**SUBJECT:** **SITE PLAN CONTROL REQUIREMENTS FOR PROCESSING FOR PHASE 1 OF 51 – 75 BRADFORD STREET AND 20 CHECKLEY STREET (BARRIE LAKESHORE DEVELOPMENTS INC.)**

### Draft Site Plan Control Requirements for Processing

**TO:** CELESTE KITSEMETRY, SENIOR PLANNER  
**NOTED:** JORDAN LAMBIE, SENIOR URBAN DESIGN PLANNER  
**RE:** D11-020-2020: 50 BRADFORD STREET – 3<sup>RD</sup> SUBMISSION  
**DATE:** APRIL 16<sup>th</sup>, 2021 (Update May 31, 2021)

*Demonstration of an 85m sight line from the signalized intersection of Toronto Street and the Marina Access to the approximate location of the proposed driveway on the subject site.*

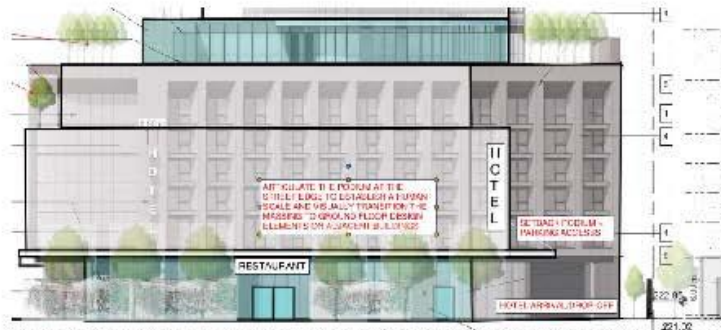
The current location of the vehicular access on Lakeshore Dr. is proposed at the south side of the site to meet TAC standards established by speed limits and stopping sight distances. A recent Council motion to explore speed limit reductions to 40km/h in the downtown may permit the consideration of locating the access to the north side of the site, potentially requiring a stopping sight distance of 85m instead of 105m.

*The proposed south elevation.*

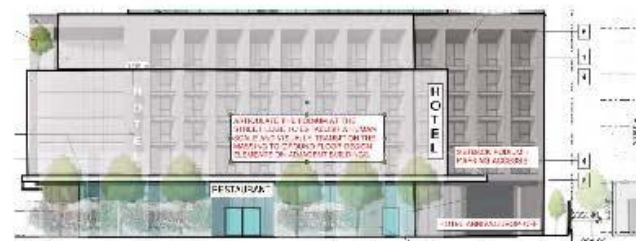
A 23.81m height is proposed for the 6 storey podium building. The *Intensification Area Urban Design Guidelines* indicate that buildings should not exceed a 45 degree angular plane taken from 80% of a R.O.W width. Staff understand the proposed width of Checkley Street will be approximately 18.6m. The podium should therefore step back in height after 14.8m (or approximately after the 4th storey). Staff generally do not support anything greater than a 1:1 ratio of building height to street width (from building face to building face). Staff recommend reducing the podium height or including step-backs on the upper levels of the podium.

*South elevation markup illustrating 1. step-backs on the podium to create a more human scale streetscape, 2. articulation to break up repetition in the façade and frame key entrances; and 3. an extension of the built form to engage and animate Lakeshore Drive with active ground level uses.*
